Q02983

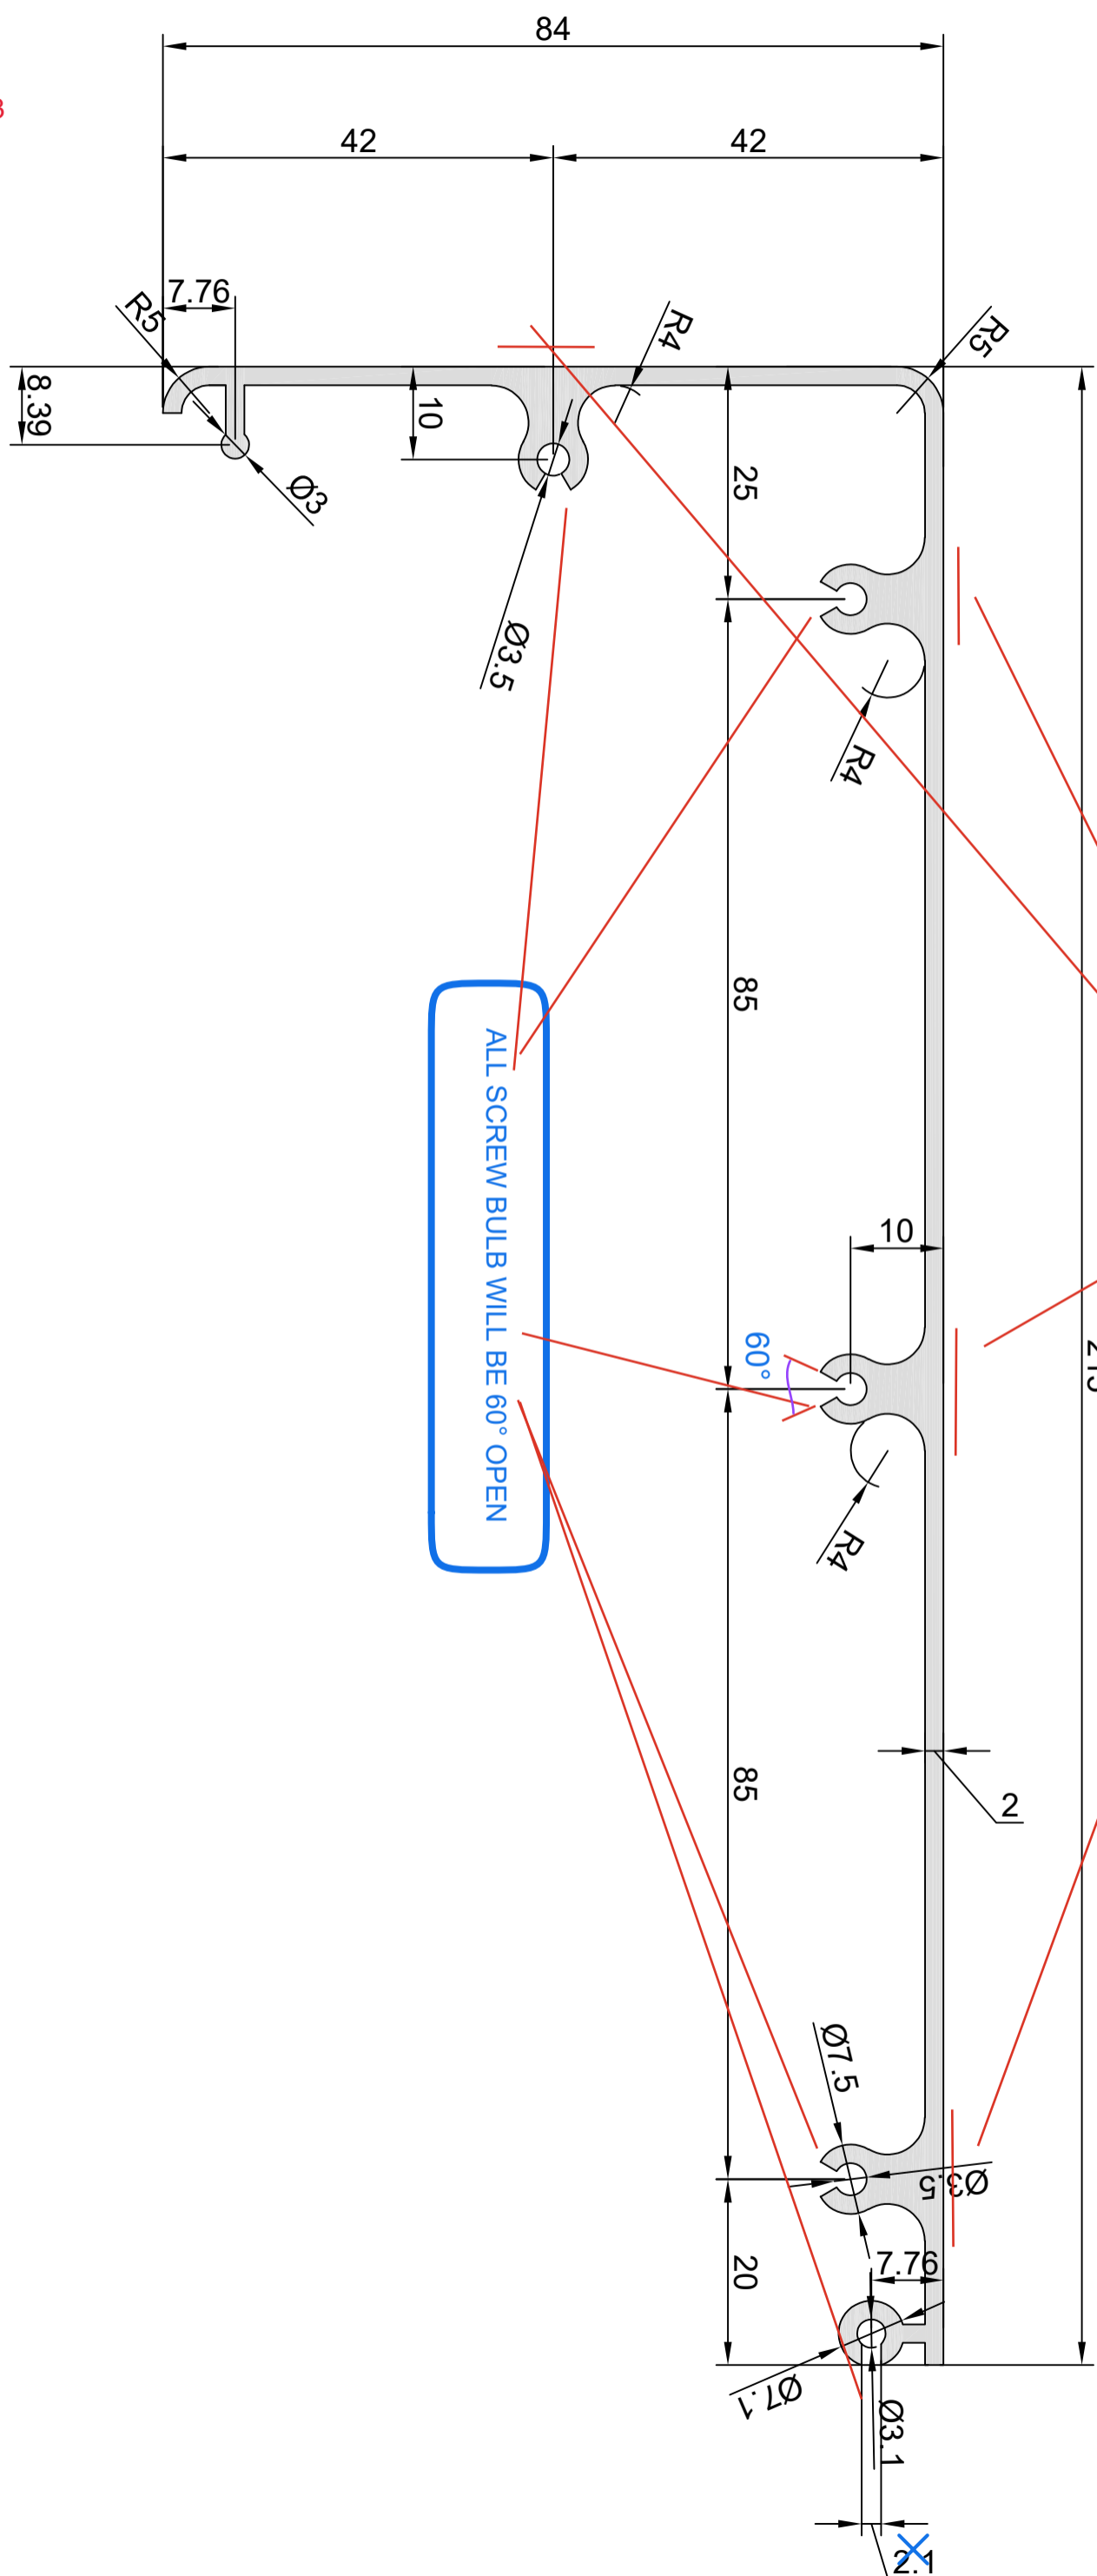
DUE TO THICKNESS VARIATION,
 WE MAY GET IMPRESSION MARK

ALL SCREW BULB WILL BE 60° OPEN
